# INTERNATIONAL BUILDING CODE – MEANS OF EGRESS

## E2-06/07

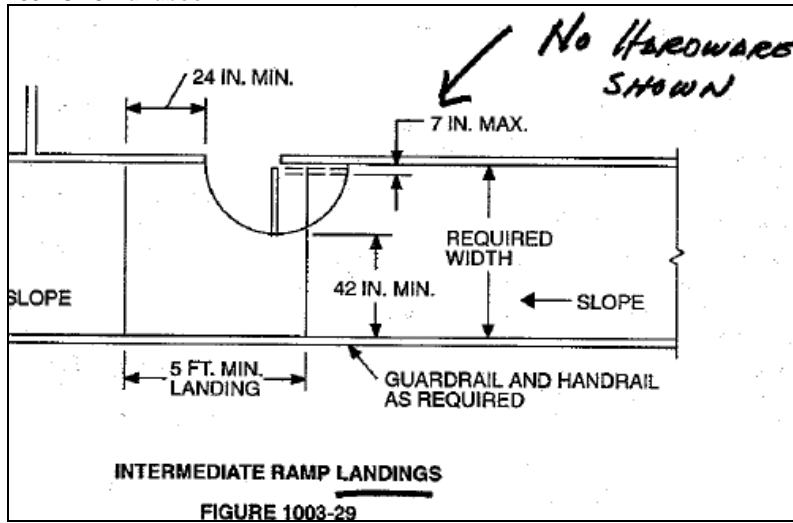
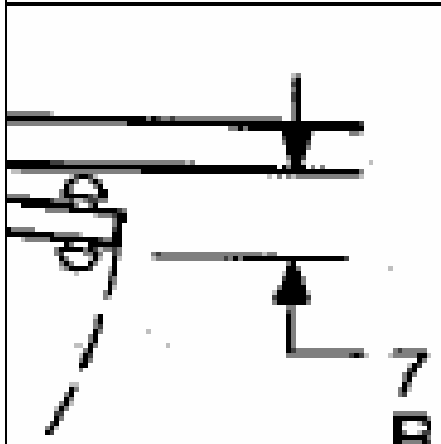
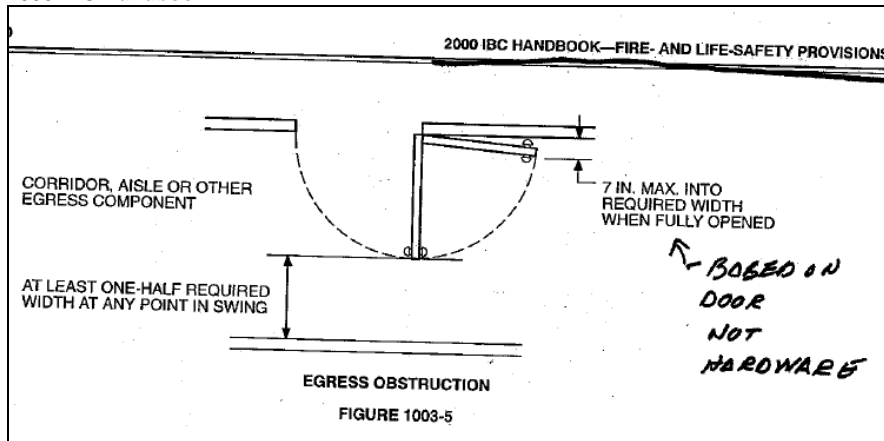
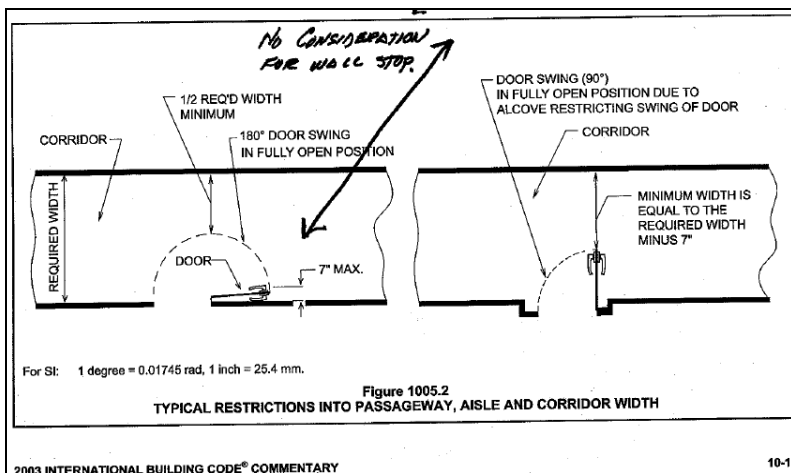
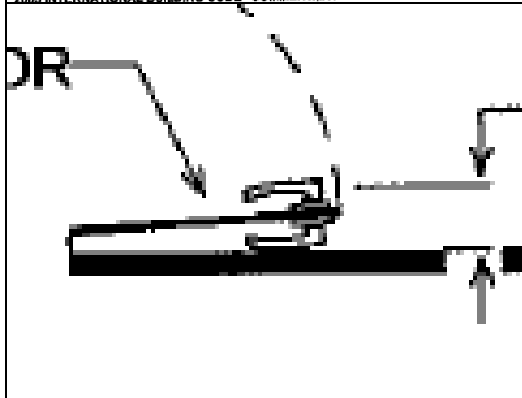
**Commenter's Reason:** The IFC and IBC requirements for door encroachment have not clearly addressed the issue of attached door latching hardware. The intent of the proposal as submitted was to clarify that door latching hardware should not be included in the dimensional requirement for door encroachment. The committee discussion and stated reasons for disapproval of E17 demonstrate the confusion surrounding this requirement. This public comment separates the door encroachment requirement from hardware, but adds restrictions on the height and mounting surface to capture the appropriate hardware encroachment prescriptions. The additional text is taken from NFPA 101 means of egress requirements.

The best illustration of just how confusing the current text is, and the best justification for this needed clarification, are the ICC Commentaries. The 7" door encroachment requirement is based upon legacy code provisions and has survived intact. In the *1997 UBC Handbook*, figure 1003-29 provides a detail with a dimension indicating a maximum of 7" door encroachment, but the figure shows no hardware and the dimension line leads to the edge of the door surface. Fast-forward to the *2000 IBC Handbook Fire and Life-safety Provisions* and to figure 1003-5. In this detail, hardware has been added to the illustration but the 7" dimension line has moved to some vague point between the door slab and the doorknob. In the *2003 IBC Commentary* Figure 1005.2, the detail has been modified to show accessible hardware instead of a doorknob, but the dimension line again leads to some vague spot on the door latch. Despite the fact that the technical provision for door encroachment has not changed since the legacy codes, ICC artists have arbitrarily changed the details in the commentaries. The clarification provided by this proposal is necessary to clean up the ambiguity and resolve the issue in order to facilitate consistent code interpretations. The proposal is not a change in the requirement, merely a clarification made necessary by the confusion created by the ICC commentaries.

The following details are taken from the above referenced ICC and ICBO publications.

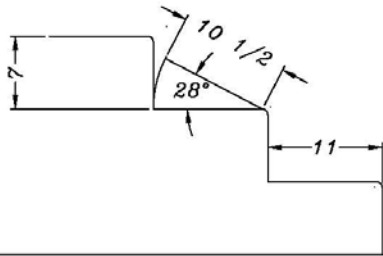
This change is all about profile, requiring projection, and using defined terms. Because of a reference to nosing projection in one of the exceptions in 1009.3 that section has been included. Suffice it to say that the requirement hidden in the exception is not necessary if our proposed changes to 1009.3.3 are accepted because the requirement will appear where it belongs in the charging paragraph of 1009.3.3.

The change in the radius from .5 inch to 9/16 inch permits the currently allowed radius of the half round profile that is used to nose treads that are manufactured to an industry standard thickness of 1-1/16 inch. This minimal change will not affect stair safety as the 9/16 inch radius is currently accepted in field inspections as a nominal variation and would match the dimension used in the IRC as well as the standard to which all wood treads are made.

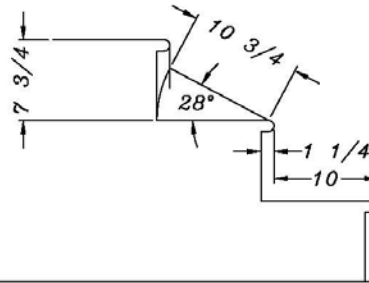
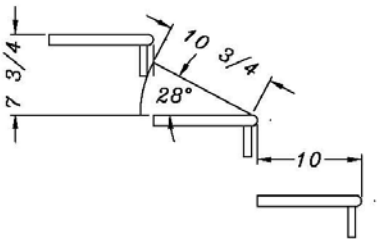
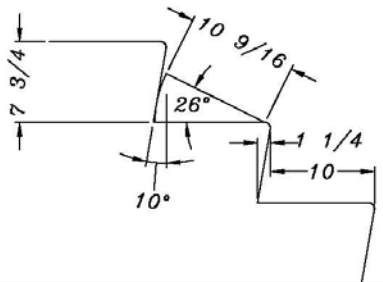
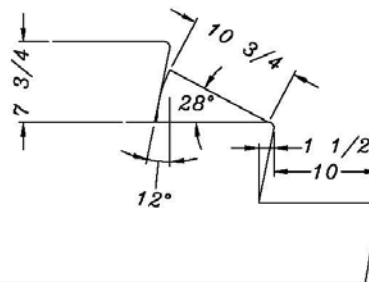
In the profile study (graphic) below it is clear to see the advantage of having a nosing projection even on treads as large as 11 inches. If a projection is not used or required the usable tread space in descent is greatly reduced. If you compare the illustration of the 11 inch tread with no projection it has less available foot space than is attained with a 10 inch tread with the required projection. I am sure you have walked on stairs with no nosing projection and wondered why it felt strange. It is because the user experiences a foreshortening of the tread and is not given the heel clearance that he or she is accustomed to related to where they normally place the ball and toes of the feet near the edge of the tread when descending. This is usually noticeable and the user must make the adjustment when no nosing projection is used. Without further study we could not recommend a minimum width that could be used without a nosing projection however requiring nosing projections makes sense. For this reason we have included 1009.3

**No Nosing Projection** - shows that foot space of 11 inch tread depth is less than conventional with only 10 inch tread depth and that a change in rise has no effect on foot space.

**Open Riser Without Projection** - shows lack of projection has no effect on foot space if opening limiter is clear of heel arc.

**Open Riser With Projection** - shows thicker treads required to reduce opening could affect available tread depth

**Sloped Riser** - shows riser angle at 1 1/4 inch projection has less available foot space than conventional

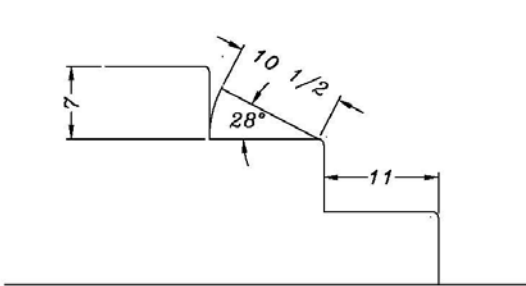
In the diagram below an 11 inch tread is shown without a nosing projection. The effective tread depth in descent is diminished when a nosing projection is not used and in the case illustrated the radius at the nosing which is normally provided to reduce wear and chipping at the nosing actually reduces the 11 inch tread depth below that of the 10 inch tread with a nosing projection of 1-1/4 inches. For this reason and others related to the effect of lower risers often used with deeper treads, larger treads should be required to have a nosing projection especially where this is normally provided and expected in residential applications. Please see graphic below illustrating the maximum space available for the heel to arc onto the tread.

**PROFILE STUDY**

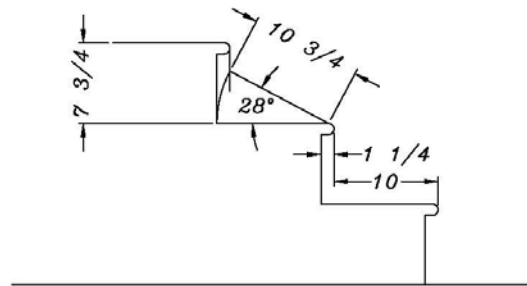
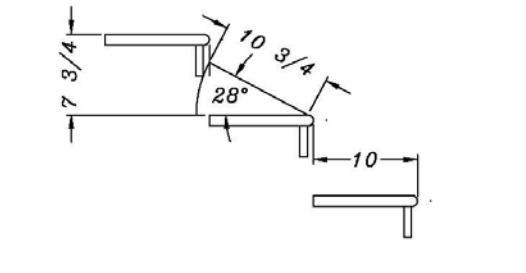
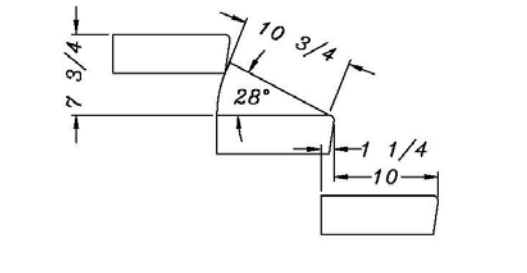
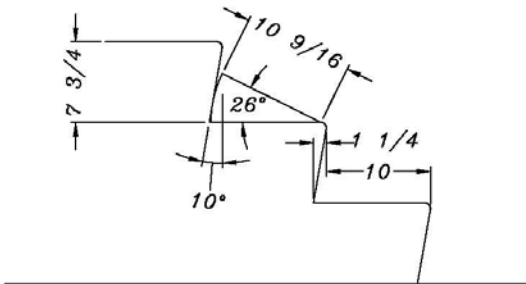
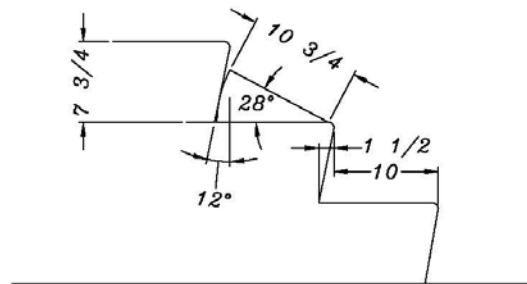
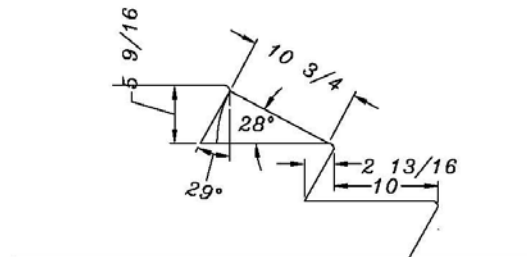
**No Nosing Projection** - shows that foot space of 11 inch tread depth is less than conventional with only 10 inch tread depth and that a change in rise has no effect on foot space.

**Open Riser Without Projection** - shows lack of projection has no effect on foot space if opening limiter is clear of heel arc.

**Open Riser With Projection** - shows thicker treads required to reduce opening could affect available tread depth

**Sloped Riser** - shows riser angle at 1 1/4 inch projection has less available foot space than conventional

Although not all possibilities are illustrated here, the intent is to show several of the factors, controlled by the sections of the ICC codes for Profile, related to the need for a nosing projection in the descent of stairways. Although the anatomy of the foot projects the heel from the back of the leg and shoe the projection is approximately 1 to 2 inches the illustrations are simply a comparison of the maximum available foot space. It is not normal for the heel to be pushed back against the riser in descent.

In each example we have drawn an arc from the restriction of space at the back of the tread to the intersection of the vertical plane of the nosing.

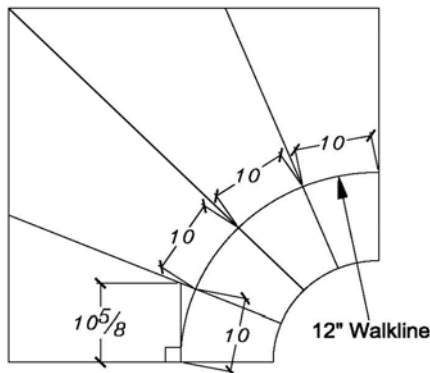
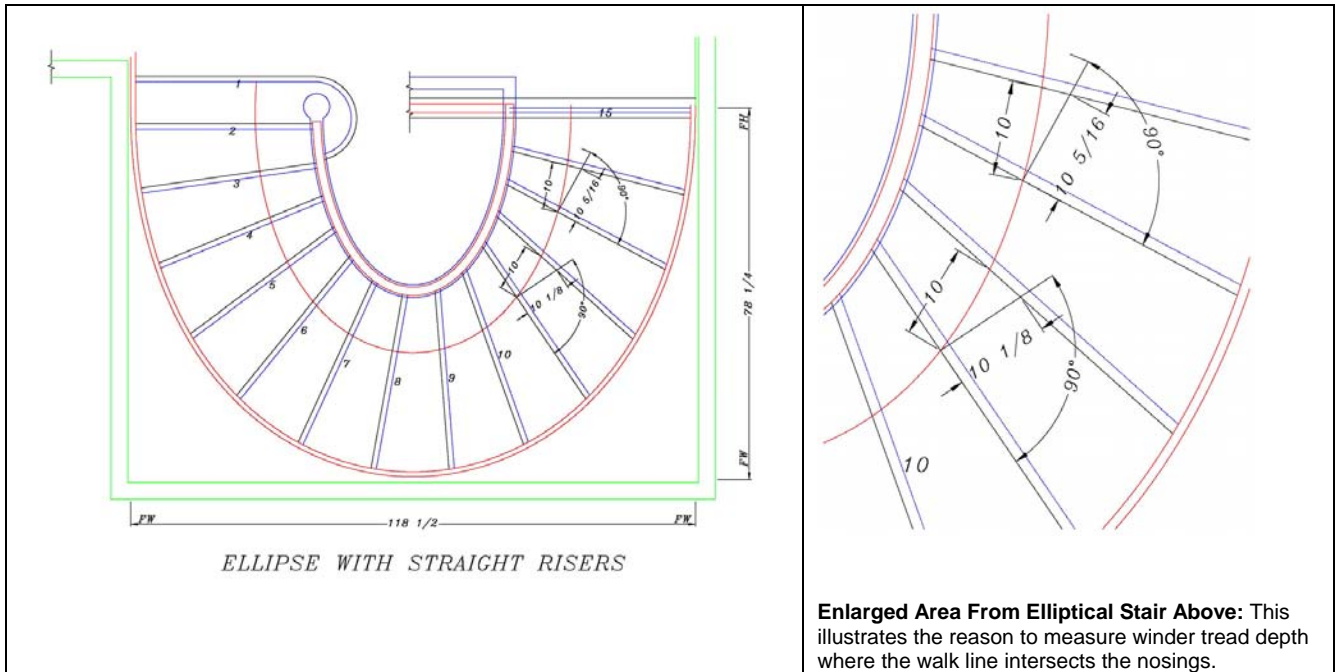
In the ICC codes all treads are recognized to be one of two types, rectangular treads (fliers) with parallel edges and winders treads with nonparallel edges. Both of these treads can be regulated for tread depth at the walk line allowing us to simplify the standard in regard to how tread depth is measured. Of course since a rectangular tread (flier) has parallel edges, its width can be regulated and measured at any point and it is understood that the code would still require this in order to determine the tread type. This test is required in the IBC because winder treads are not permitted in some egress stairs and both the IBC and IRC regulate winder tread depth at two points. This proposal allowing all treads to be regulated at the walk line offers us the opportunity to simplify the text in regard to the measurement criteria and establish a method that works for all treads.

The tread depth measuring method prescribed by this proposal allows the tread depth to be measured at the intersection of the walk line and the nosing or leading edge of the tread. This is critical to equal division of curved walk lines and the formation of uniform winder treads. This is clearly explained in the attached graphics that show the discrepancies when measuring winders by the current method. The current method is flawed and results in irregular distribution of the treads edges that do not correlate with the user's experience

Further clarification is given to the concern for measuring depth of winder treads by establishing that both the 6 inch minimum measurement and the walk line measurement are to be taken on the "usable" portion of the tread where the foot can be placed when traversing the stairway. Although this is the historic basis for this measurement this simple word will allow more consistent interpretation and enforcement. To further simplify and eliminate the need to prescribe a particular place on the tread to verify the narrow end (10inch or 6 inch) measurement the words "at any point" allows for less confusion in measuring treads that may have narrowing at two points.

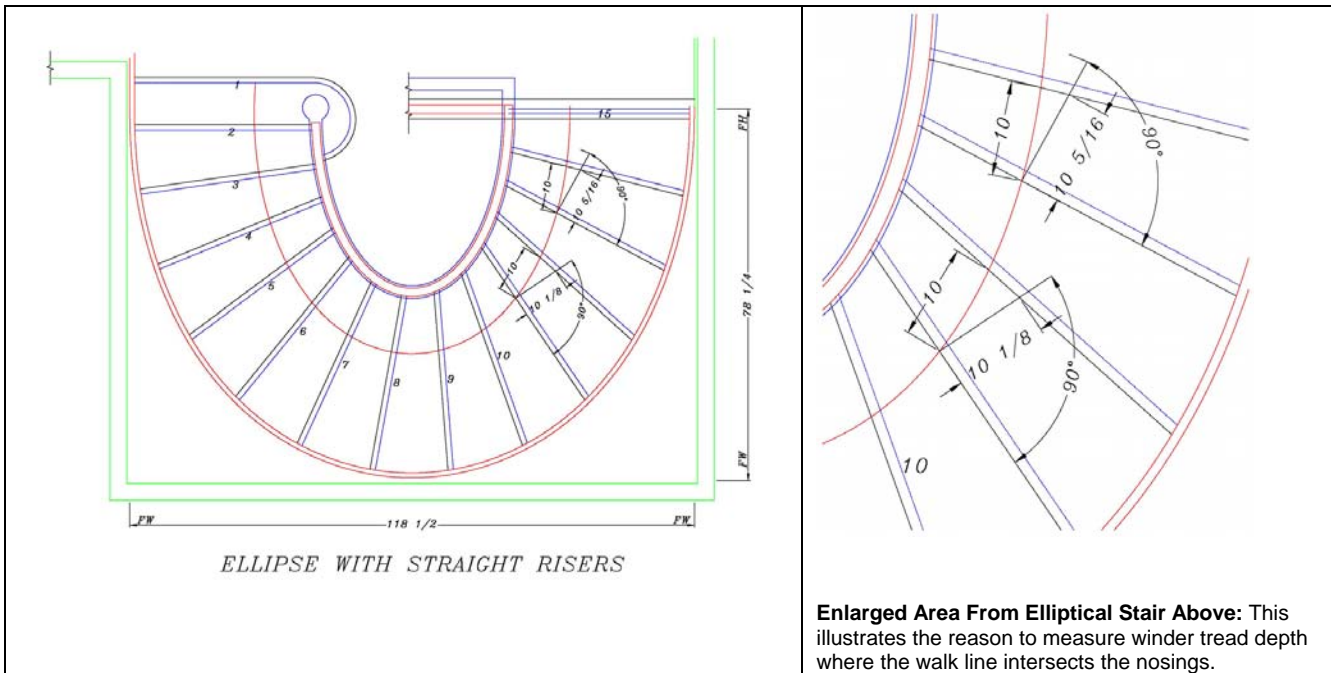
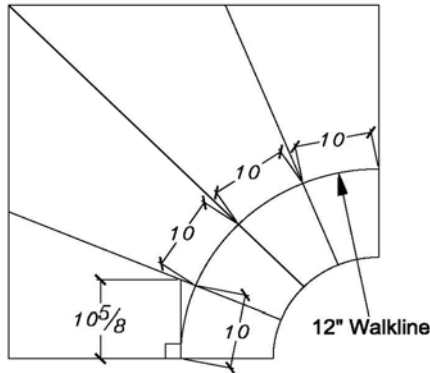
In the ICC codes all treads are recognized to be one of two types, rectangular treads (fliers) with parallel edges and winder treads with nonparallel edges. Both of these treads can be regulated for tread depth at the walk line allowing us to simplify the standard in regard to how tread depth is measured. Of course since a rectangular tread (flier) has parallel edges, its width can be regulated and measured at any point and it is understood that the code would still require this in order to determine the tread type. This test is required in the IBC because winder treads are not permitted in some egress stairs and both the IBC and IRC regulate winder tread depth at two points. This proposal allowing all treads to be regulated at the walk line offers us the opportunity to simplify the text in regard to the measurement criteria and establish a method that works for all treads.

The tread depth measuring method prescribed by this proposal allows the tread depth to be measured at the intersection of the walk line and the nosing or leading edge of the tread. This is critical to equal division of curved walk lines and the formation of uniform winder treads. This is clearly explained in the attached graphics that show the discrepancies when measuring winders by the current method. The current method is flawed and results in irregular distribution of the treads edges that do not correlate with the user's experience.

Further clarification is given to the concern for measuring depth of winder treads by establishing that both the 6 inch minimum measurement and the walk line measurement are to be taken on the "usable" portion of the tread where the foot can be placed when traversing the stairway. Although this is the historic basis for this measurement this simple word will allow more consistent interpretation and enforcement. To further simplify and eliminate the need to prescribe a particular place on the tread to verify the narrow end (10 inch or 6 inch) measurement the words "at any point" allows for less confusion in measuring treads that may have narrowing at two points.

**Diagram 1.** Sections A to Q were tested biomechanically by Maki (1985, 1988). Diagonal shading marks recommended sections. Large crosses mark those performing poorly.

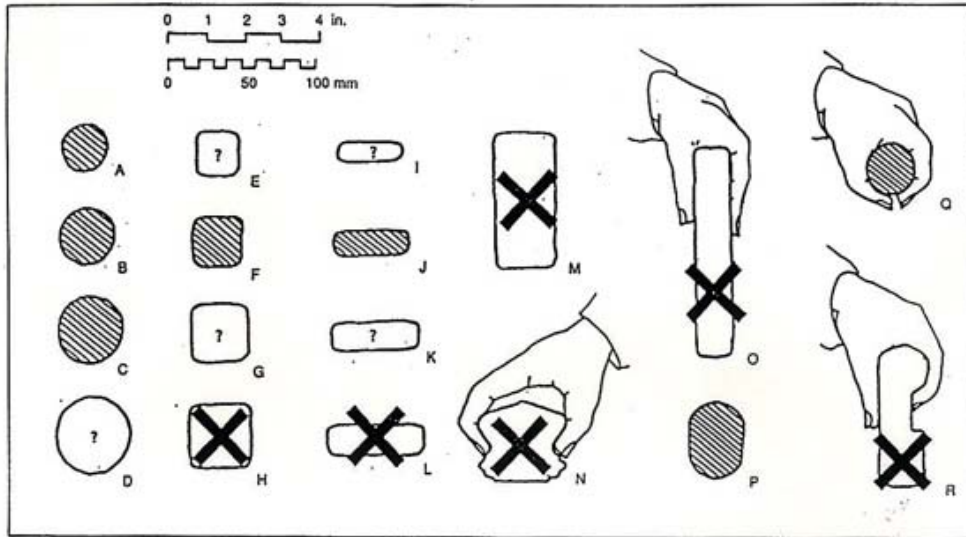
Appendix with some of the prior input, from Jake Pauls, critical of previous proposals which attempted to have pinch-grip only railings accepted by the codes. **(See the SMA website, [www.stairways.org/codes\\_standards.htm](http://www.stairways.org/codes_standards.htm), for downloadable PDFs, “Visual Code Interpretations,” depicting even worse decorative railings purported to meet the Type II requirements SMA has gotten into the International Residential Code.)**

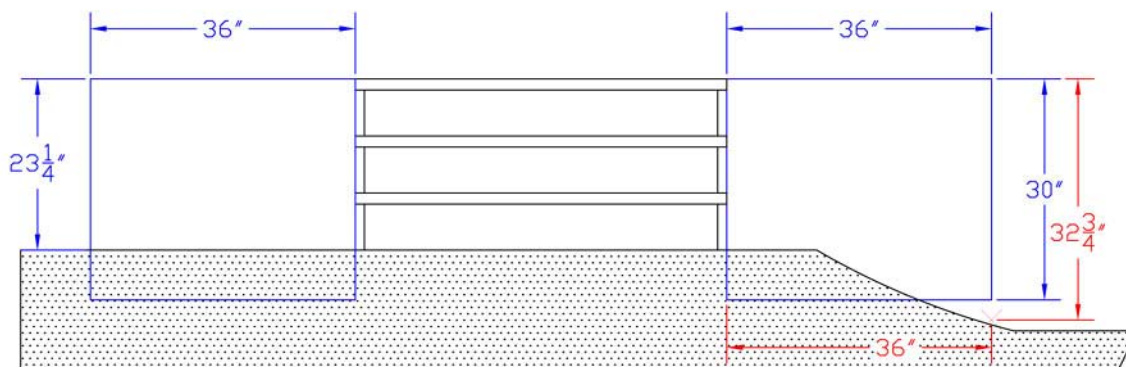
**Commenter's Reason:** The code change committee sites in their reason that this issue is a "work in progress". While this is true regarding the CTC's review of the subject of climbable guards as far as testing, the CTC has concluded its review and solicitation of comments on the subject matter included in this proposal. The following revisions are proposed in response to the code committees concerns:

IBC 1013.1 Height measurement: This public comment is submitted in order to clarify how the height measurement which triggers the guard requirement is made relative to proximity to the adjacent fall-off. This is illustrated in the following figure:

The view is taken from the landing of a 3 riser stair, looking towards the face of the risers.

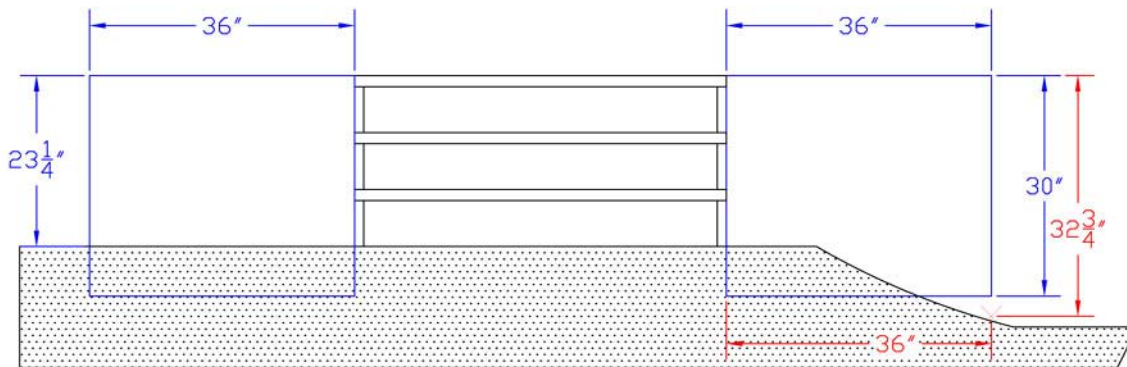
**R312.2 Height.** Guards at open-sided walking surfaces, including stairs, porches, balconies or landings, shall be not less than 36 inches (914 mm) high measured vertically above the adjacent walking surface, adjacent fixed ~~seat boards~~ seating or the line connecting the leading edges of the treads.

IRC R312.2 Height measurement: This public comment is submitted in order to clarify how the height measurement which triggers the guard requirement is made relative to proximity to the adjacent fall-off. This is illustrated in the following figures:

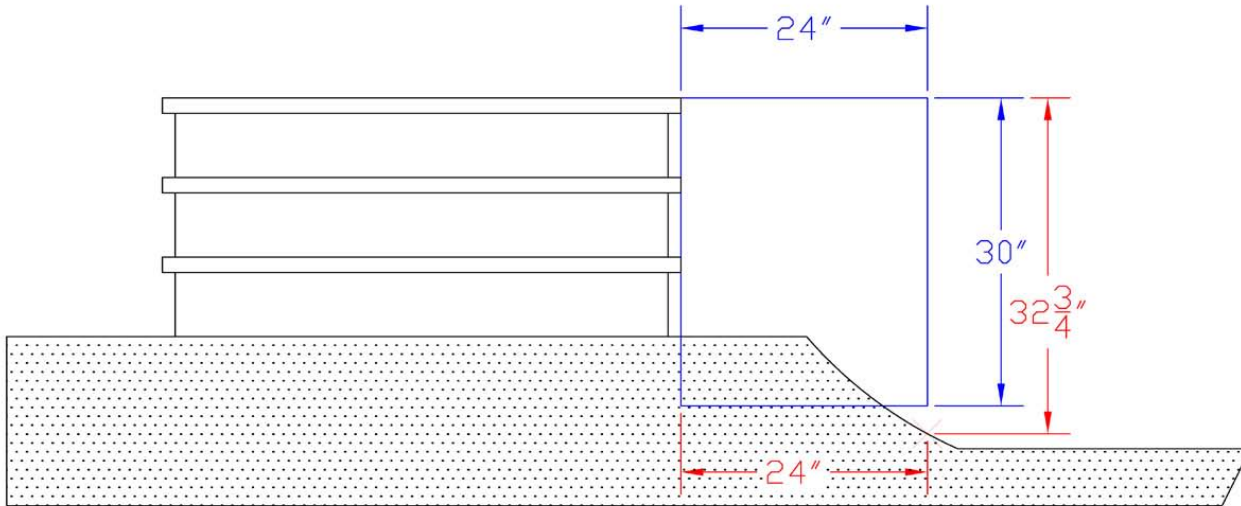
The diagram below was drawn by the author and is shown as a visual guide or technical drawing. The drawing shows a 3 riser front entry stoop with 7-3/4" risers from a front elevation. The ground is detailed in outlined dots. The 24" horizontal with 30" vertical box shows the area in which the code change submits the measurements should be taken. The 32-3/4" vertical point shows the deepest point within the 24" horizontal edge measurement.

Thus if this stoop was on a home it would require a guard be installed on the right side only as the left side is not 30 inches or more deep.
